Access Compliance Report

Public Rights-of-Way

| Intersection ID: 14014 | Main Street: N_SHARON_AMITY_RD | Cross Street: WILORA_LAKE_RD | Location: NE |
| ADA ID: 32E42BC511F8 | Ramp Type: Perp | Initial Pass/Fail: Fail | Overall Compliance: No |

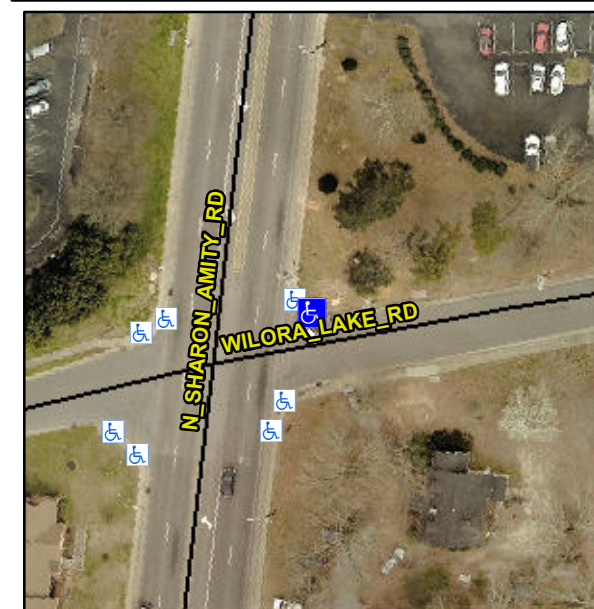
Not Found, R304.5.1, R304.2.2

| Compliance | Description | Data | Compliance | Description | Data |
|------------|-----------------------|------|------------|-----------------------------|------|
| N/A | Ramp Length (in) | 58.0 | No | Ramp Slope (%) | 11.1 |
| No | Ramp Width (in) | 42.0 | Yes | Ramp XSlope (%) | 1.4 |
| N/A | Gutter Ponding? | Yes | N/A | Gutter Slope (%) | N/A |

Remove & Replace Entire Ramp.
